NEW MEXICO OIL CONSERVATION DIVISION

Apache 25 Fed. #8
30-015-33439

Devon Energy
(234728)

RE: Form C-108, Application for Authorization to Inject
Apache 25 Federal #8; API# 30-015-33439
Eddy County, NM
Section 25, T22S, R30E

5. Please send a production plot of this well (with applicable open perforations marked) from the first date of production to the last.

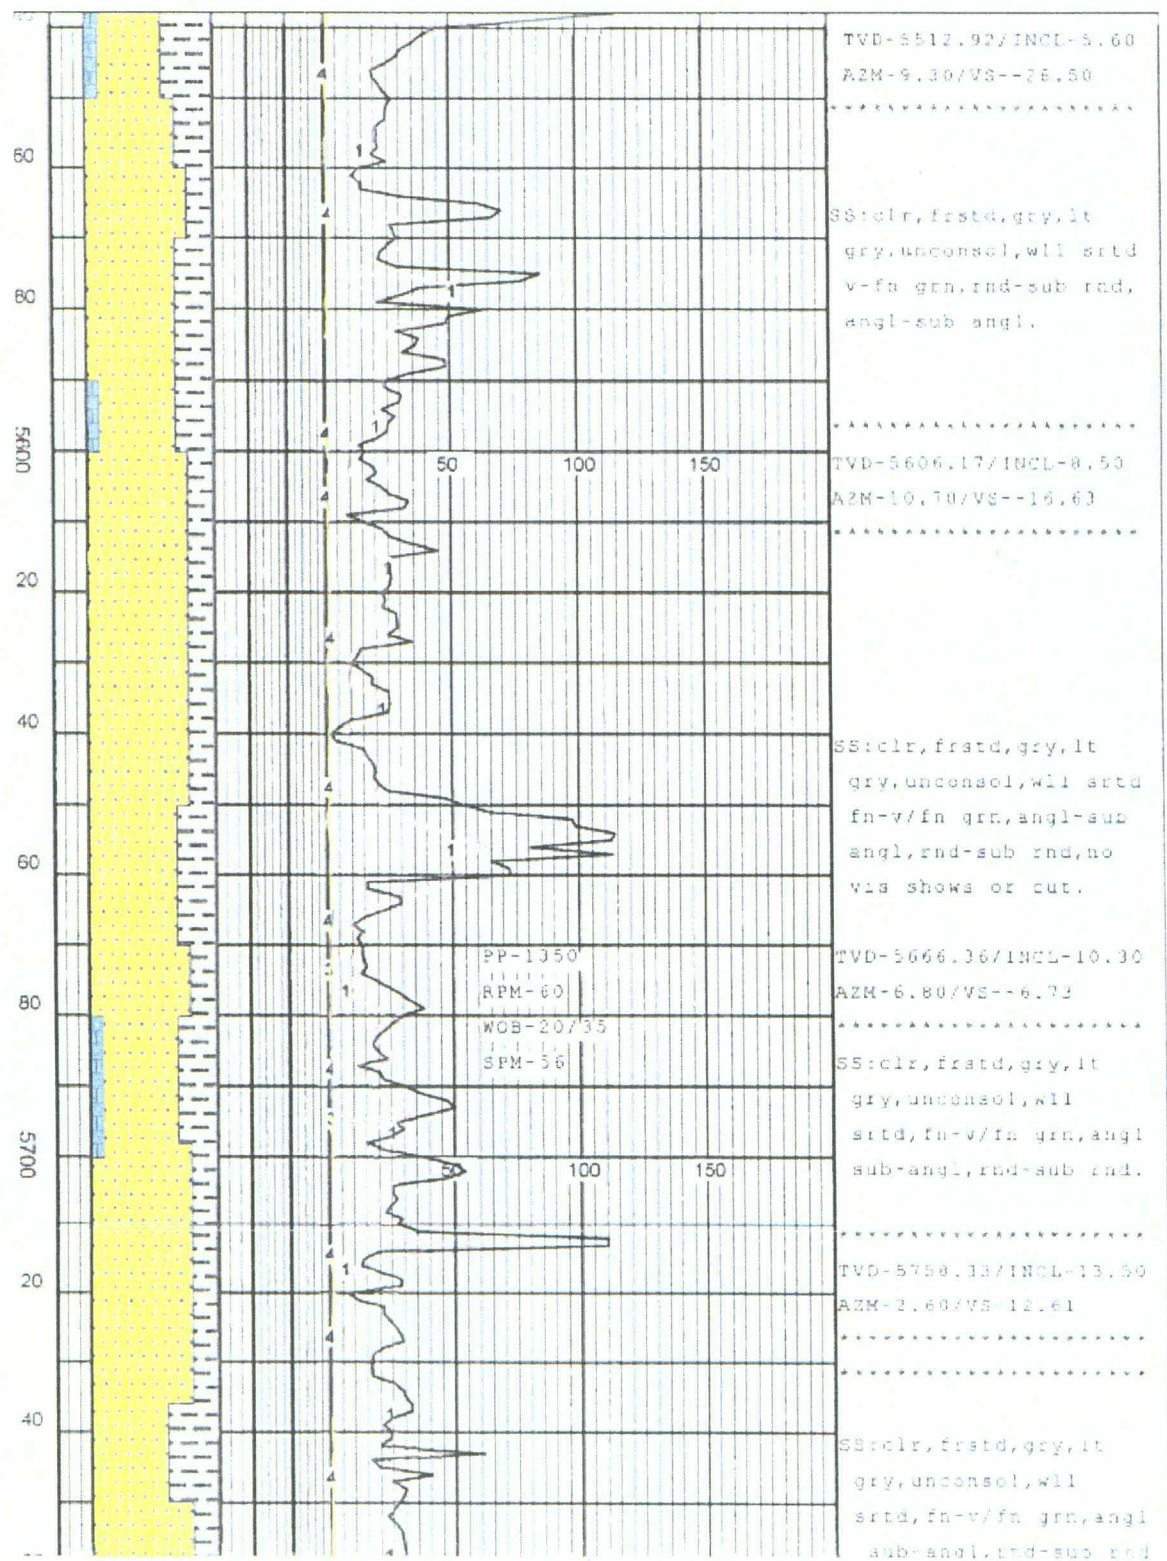
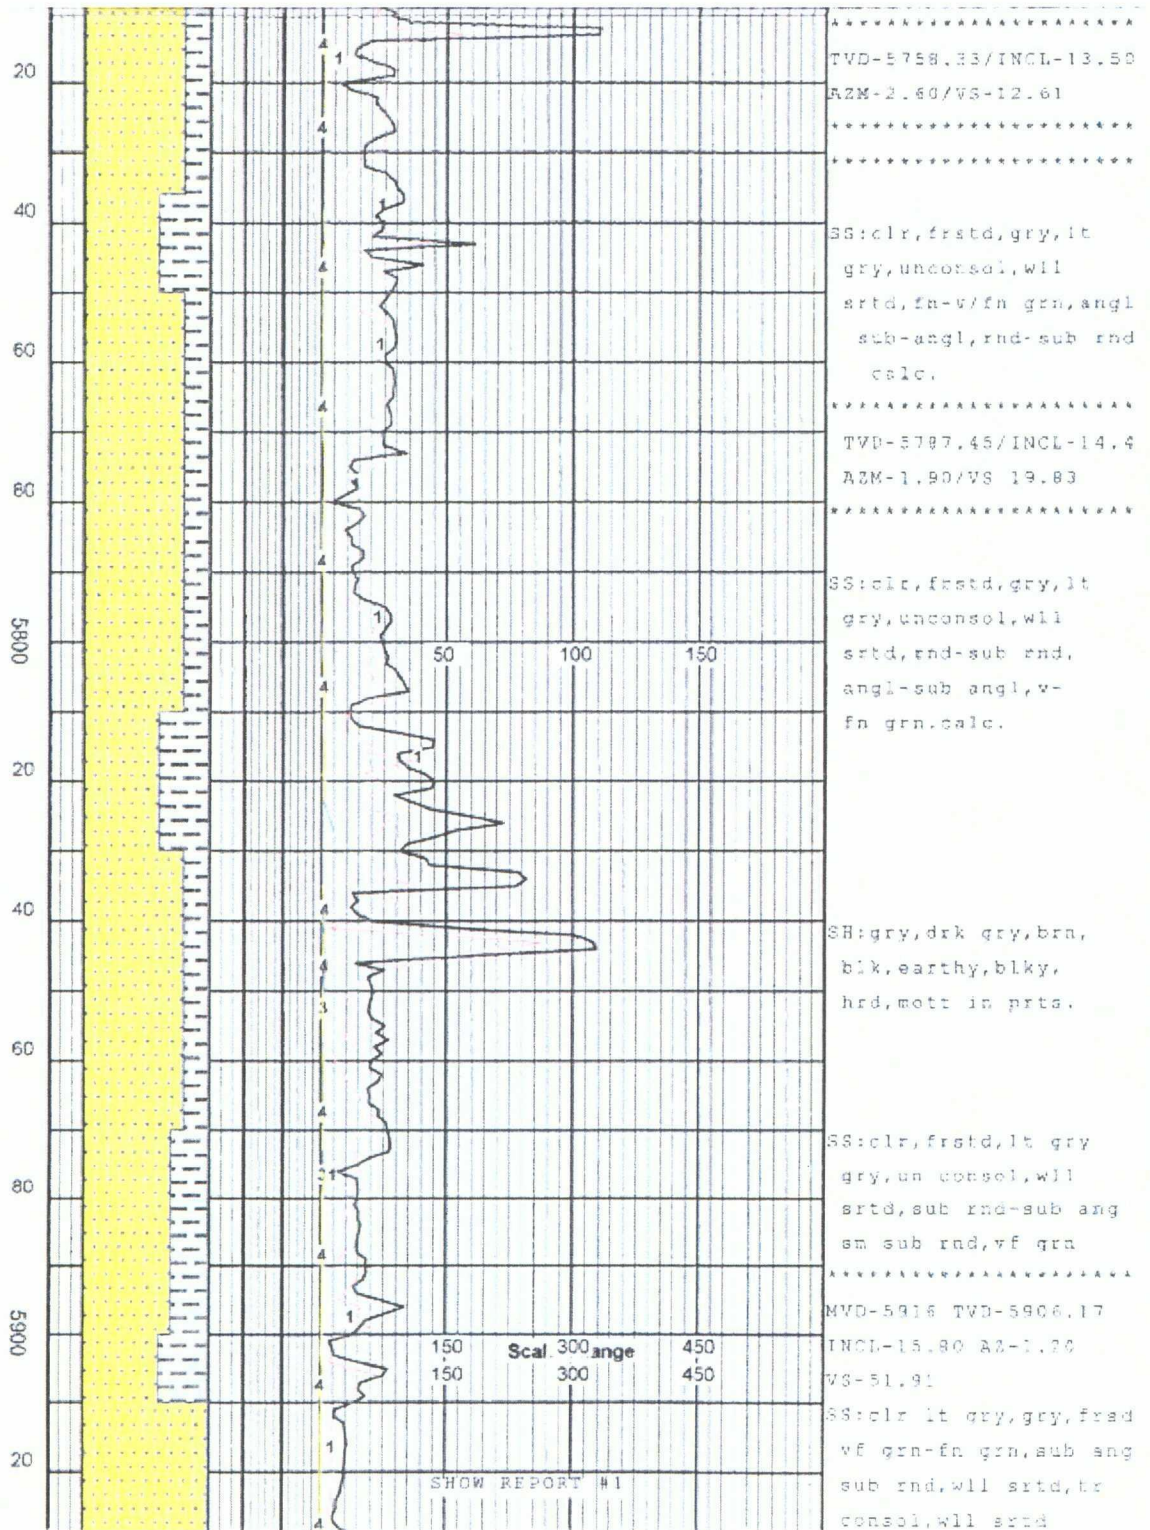
6. Why was this well chosen for disposal rather than the other wells?

7/30/04: Perforated 7660' – 7682'; 4/4/05: Perforated 7018' – 7404'; 2/14/06: Perforated 5920' – 6867'.

As you can see from the production graph above, this well is uneconomic due to the extremely high water cut. Rather than P&A this well, we found that this would be a prime candidate for an injection well. We are looking at the future, and with more
